ADDENDUM NUMBER ONE (1)
CATAWBA COUNTY
BLACKBURN RESOURCE RECOVERY FACILITY OPERATOR'S BUILDING
PROJECT NO. 26.00701

This Addendum Number One (1) is issued this the 14th day of October 2026, to all parties who hold a set of Bid Documents for the project entitled: **“BLACKBURN RESOURCE RECOVERY FACILITY OPERATOR'S BUILDING”**. This Addendum Number One (1) shall become part of the Contract Documents and its receipt acknowledged on the bid documents at the time of bidding.

SHEET NO.
A110

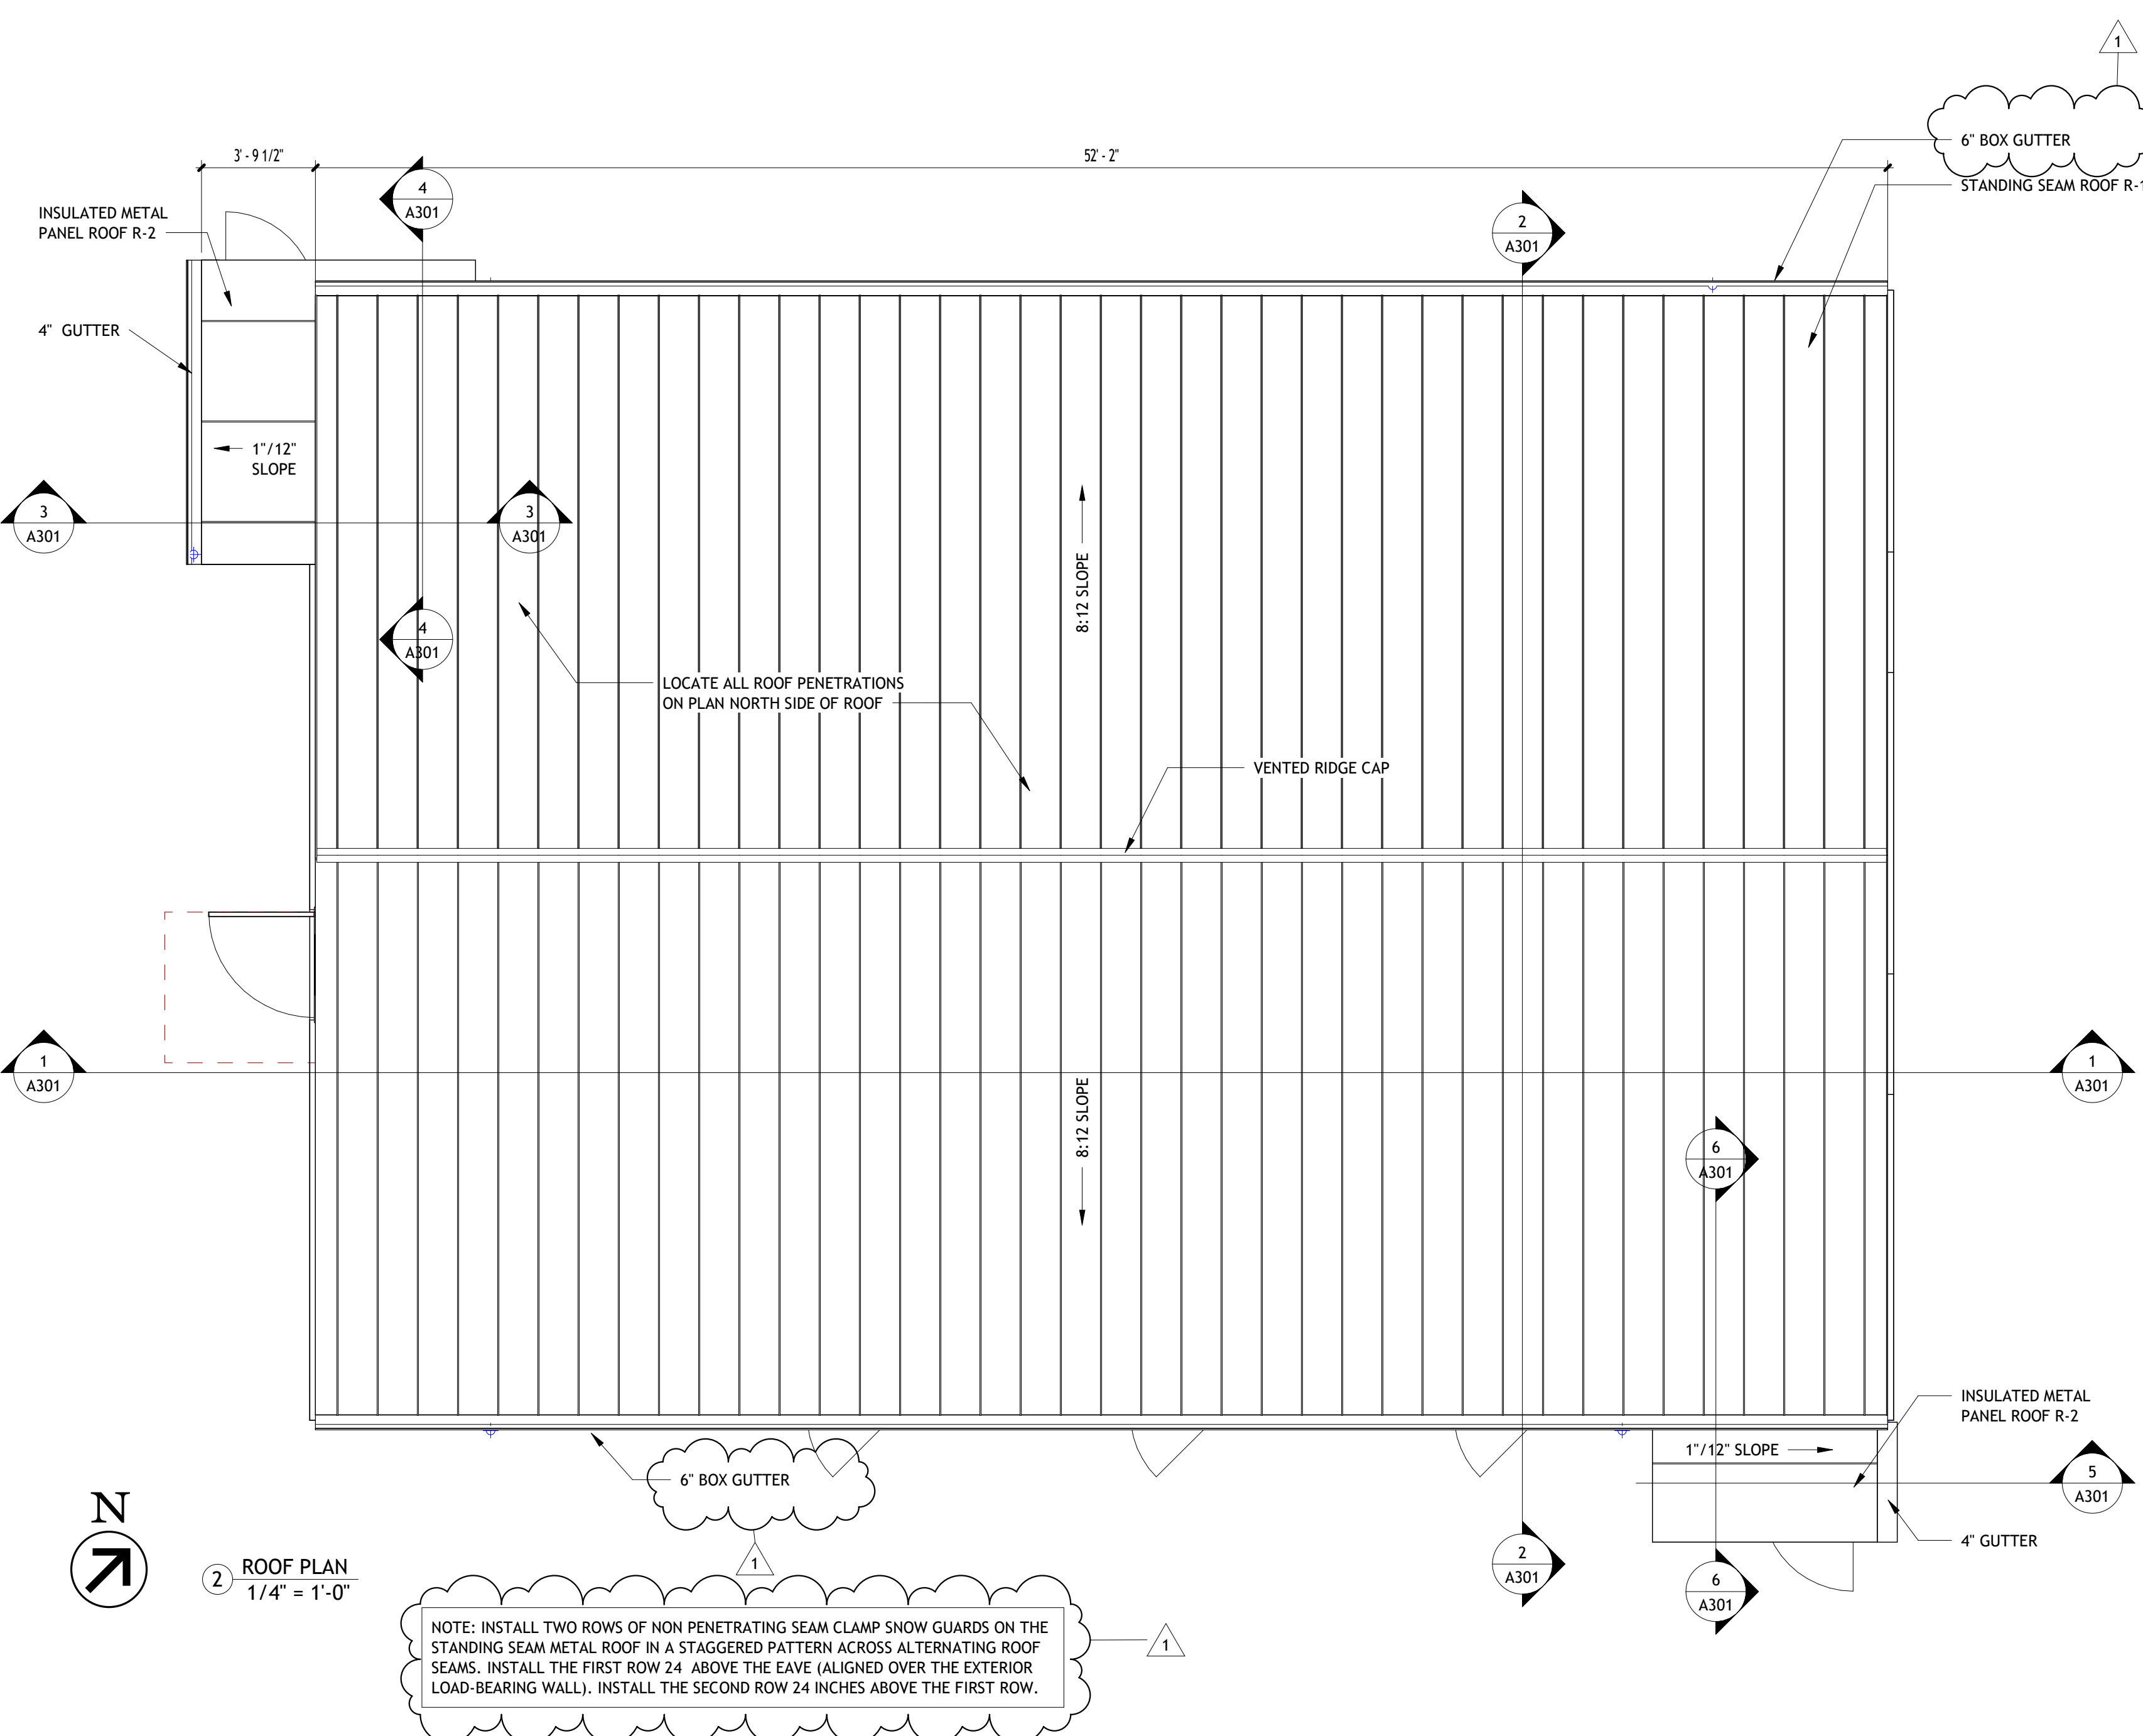
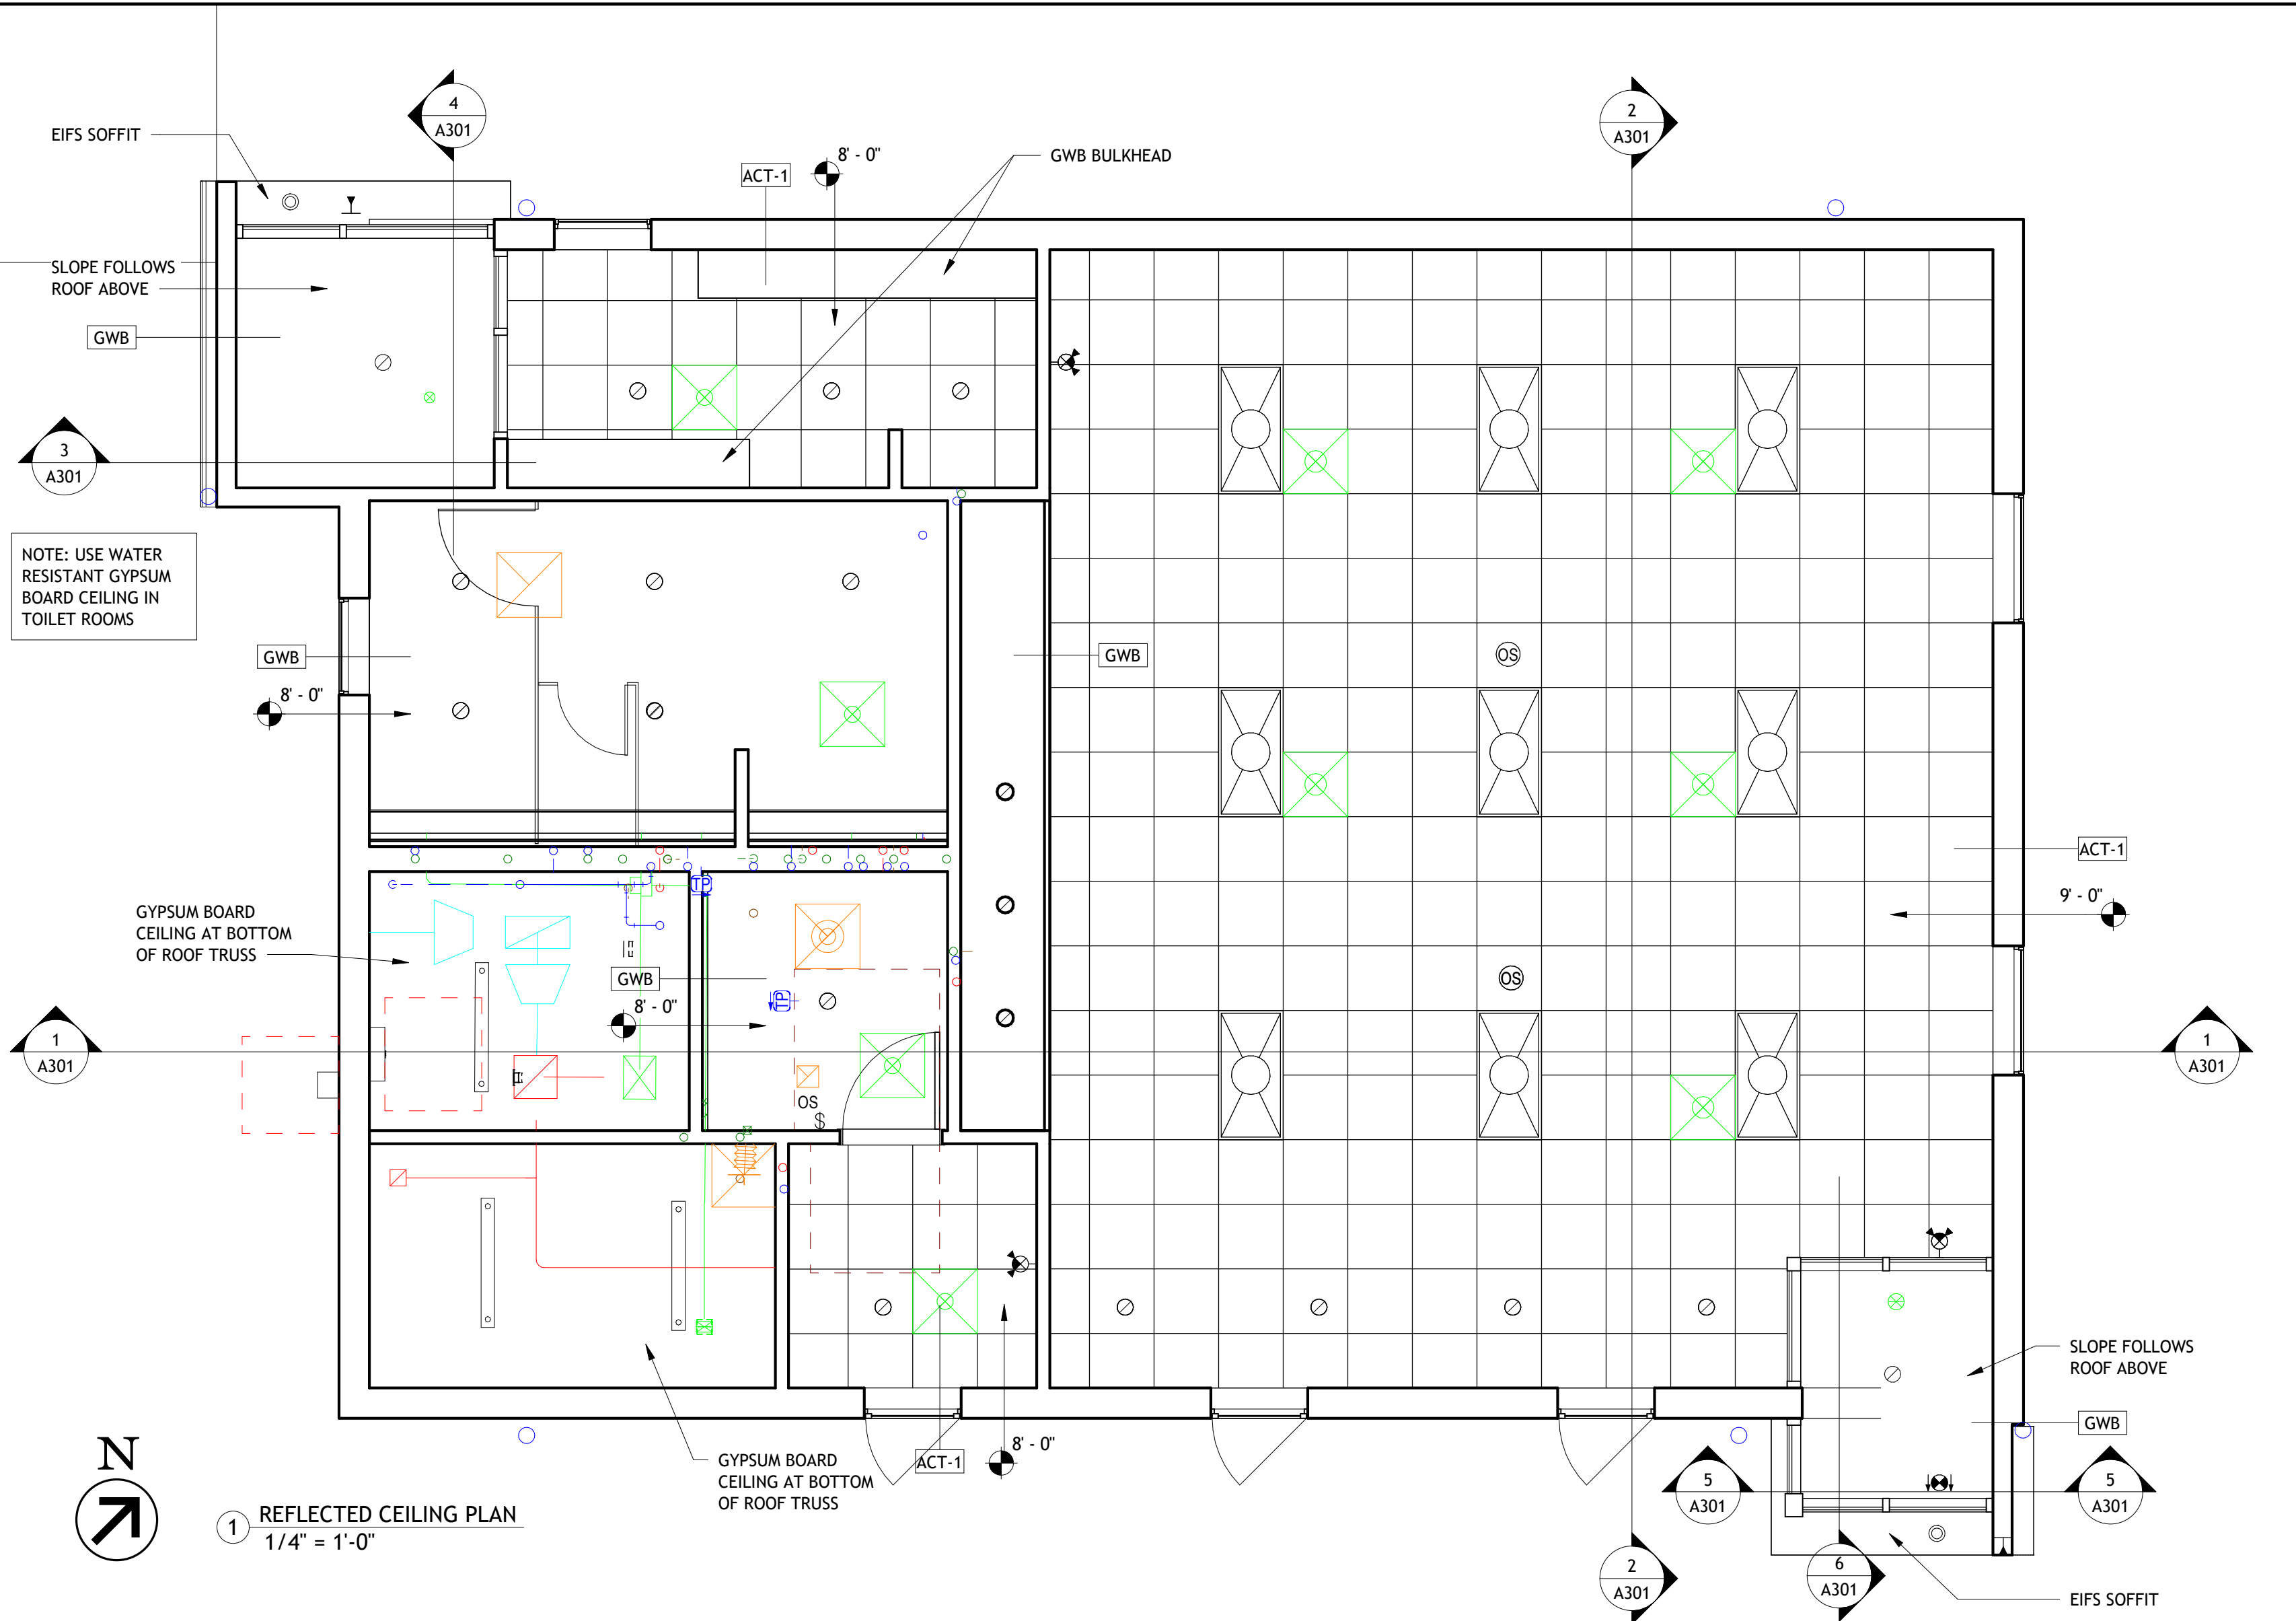
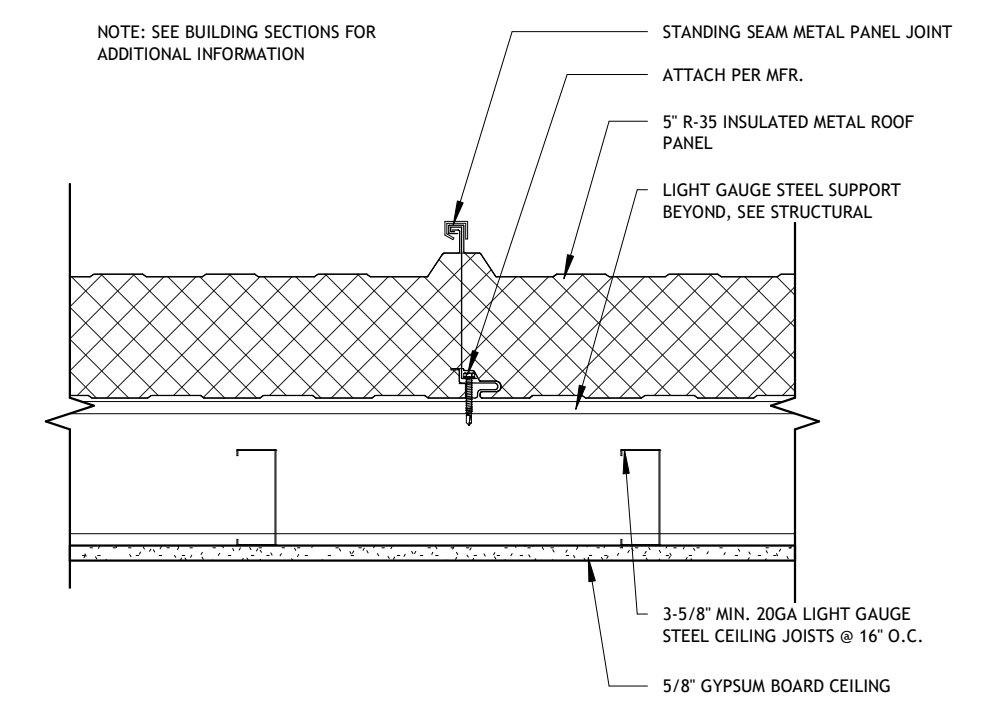
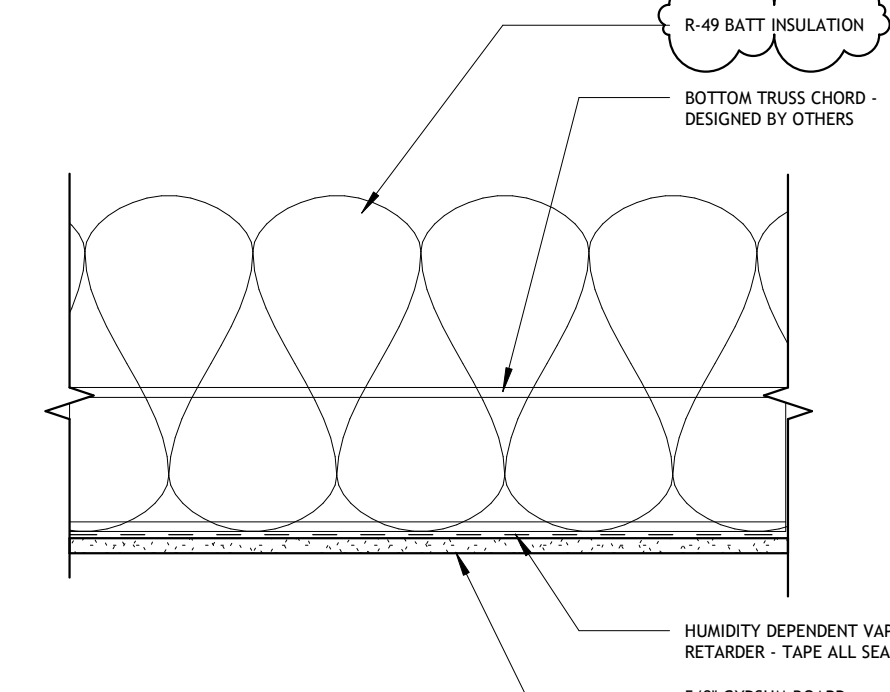
1. Drawings: The below information includes changes, revisions, and updates to the drawings from the original bid set. Please replace the following sheets.
 - a. *Sheet A110*: Revisions made to gutter system and attic insulation types.
 - b. *Sheet A201*: Revisions to gutter system.
 - c. *Sheet A301*: Revisions made to attic insulation type.
 - d. *Sheet A310*: Revisions to gutter system and inclusion of ice and water shield.

- *Could standard commercial gutters be substituted for the 8" round design?*

- *Will the insulation be blown cellulose or batt insulation in the attic?*

- *Are snow guards required?*

6" Commercial box gutters are acceptable. Please see revisions to sheets A110, A201 & A310.

Attic insulation to be batt. Please see revised sheets A110 & A301 in Addendum No. 1.

Yes, snow guards are required for the standing seam metal roof. Please see revised sheet A110 with added notes on snow guard requirements.
